ADDENDUM NO. 3

**RE: NCDAC NC Correctional Institution for Women
Air Conditioning Installation
SCO ID#: 22-24913-02A
NCDAC Central Engineering Job Order # 4290**

DATE: September 12, 2023

1 PHOENIX, FALCON, AND SPARROW DORMS - MODIFIED FIRE ALARM SYSTEM RISER DIAGRAM
E602 NO SCALE

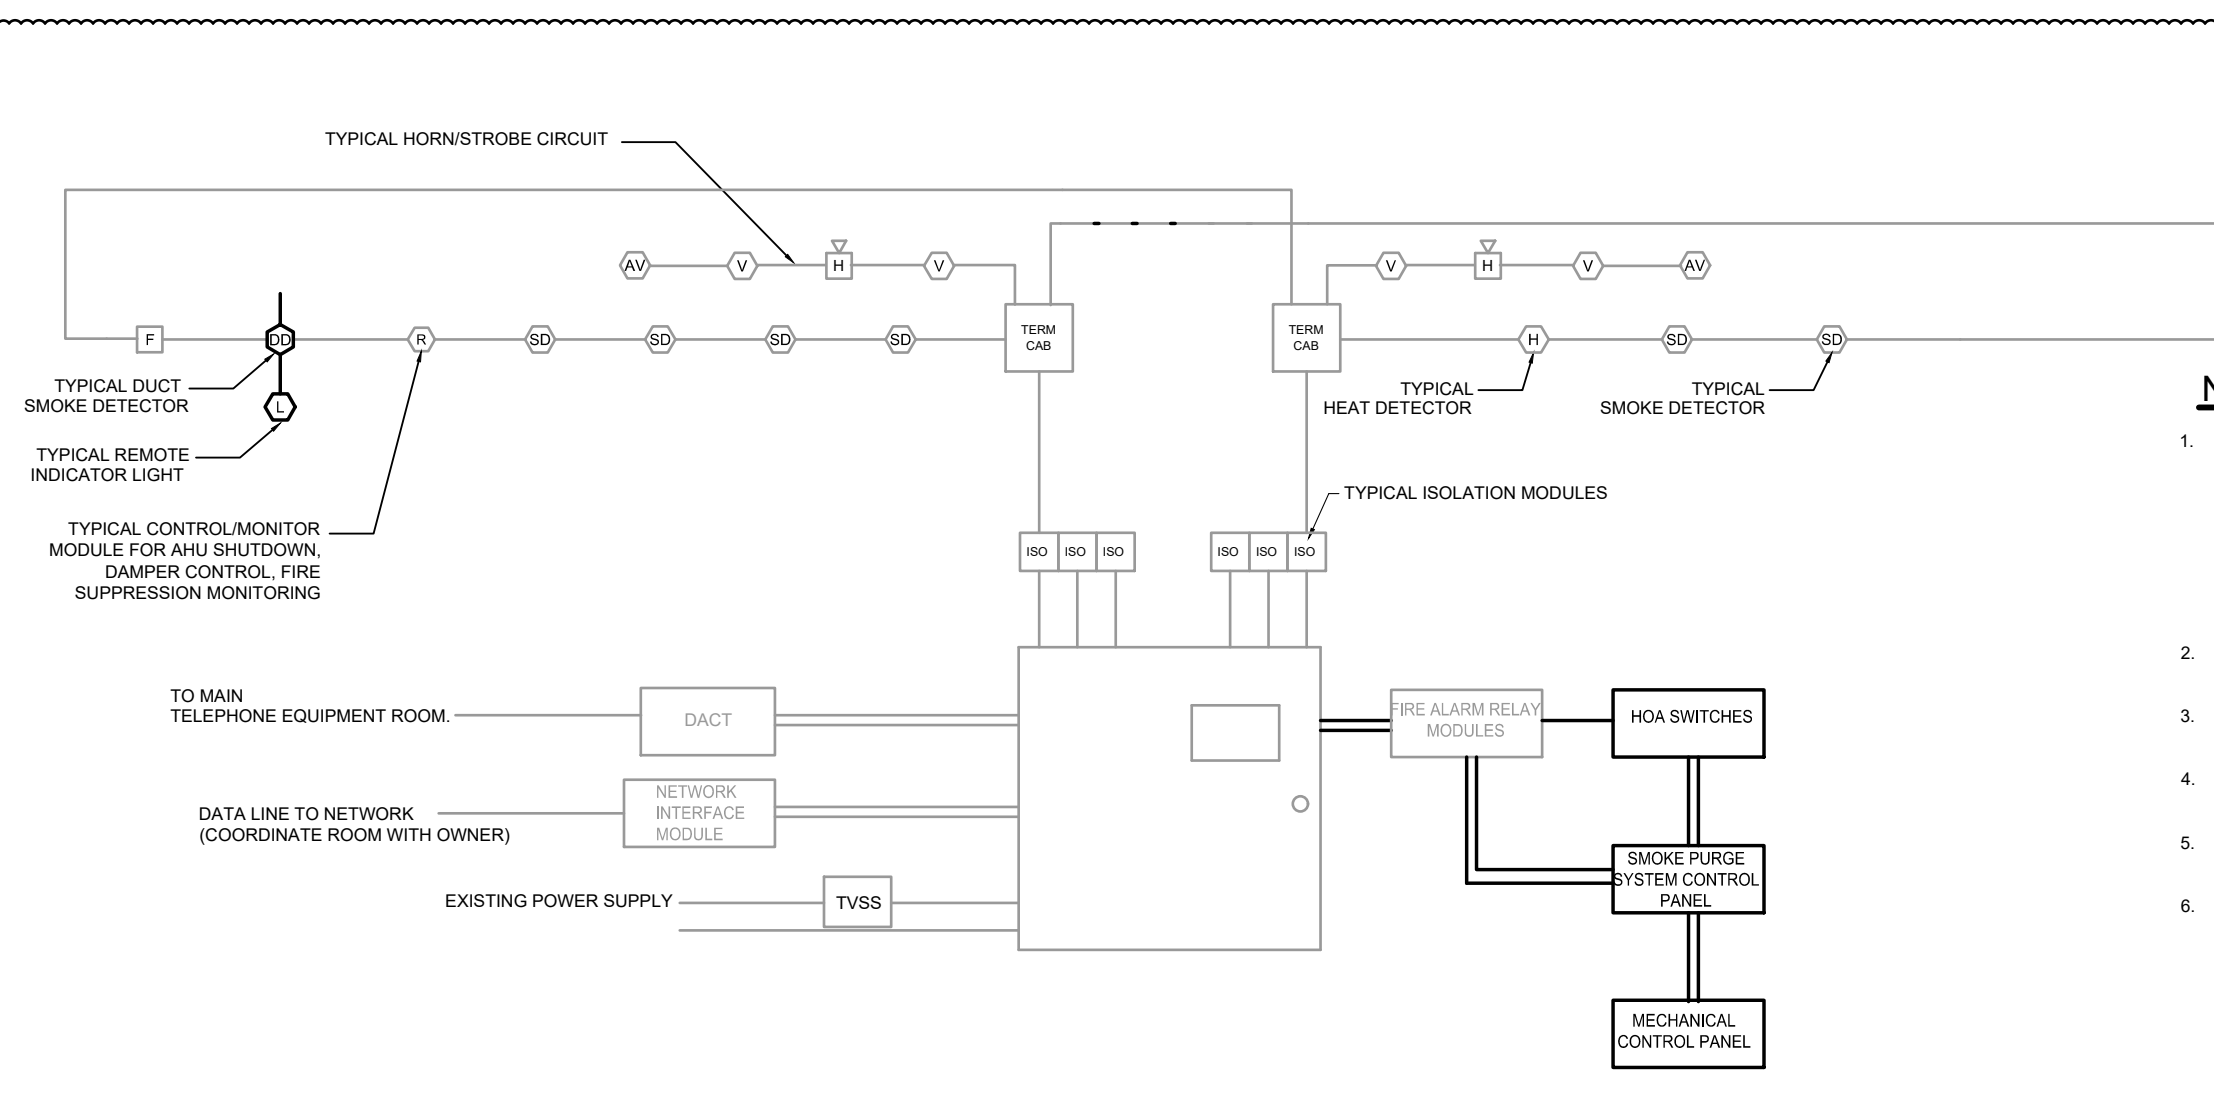
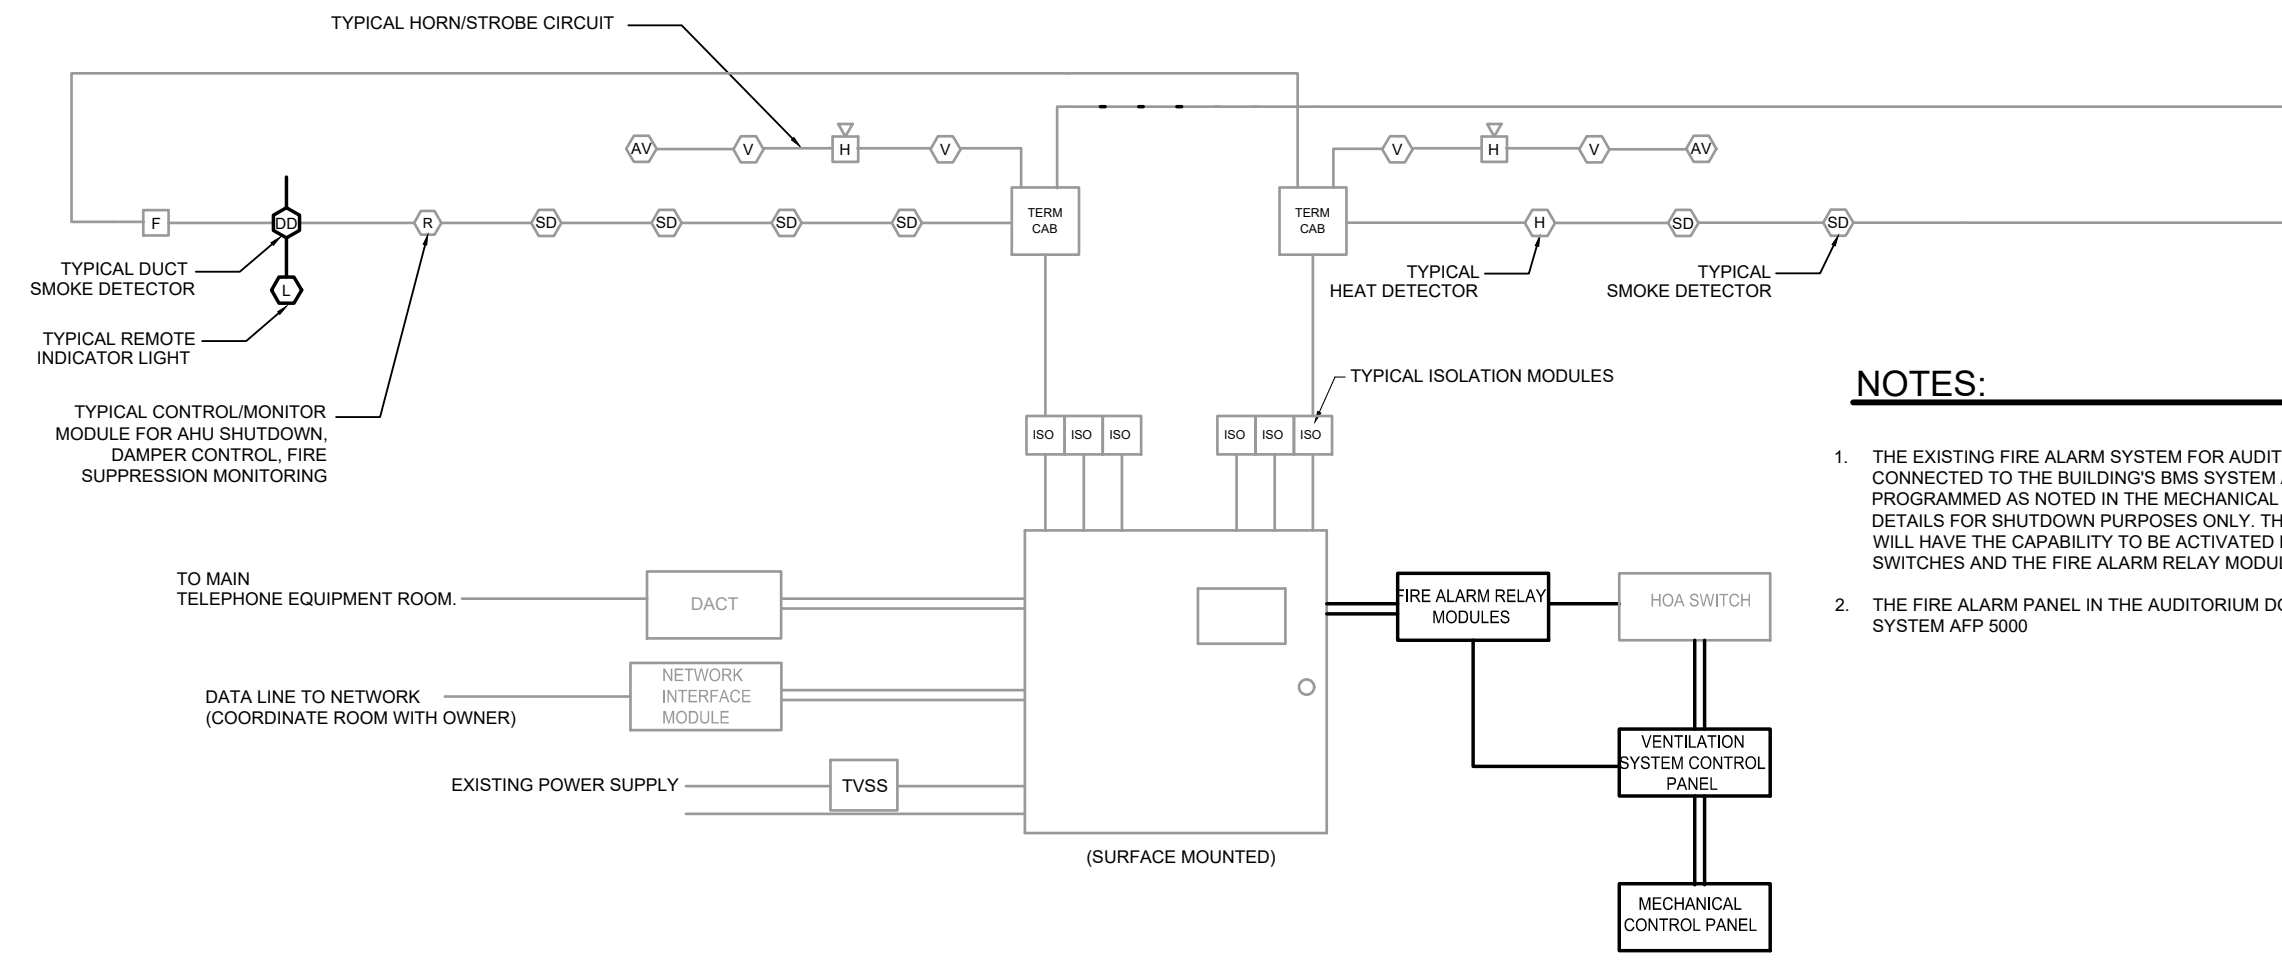
21. Sheet E141: See revisions on attached sheet.
22. Sheet E602: See revisions on attached sheet.
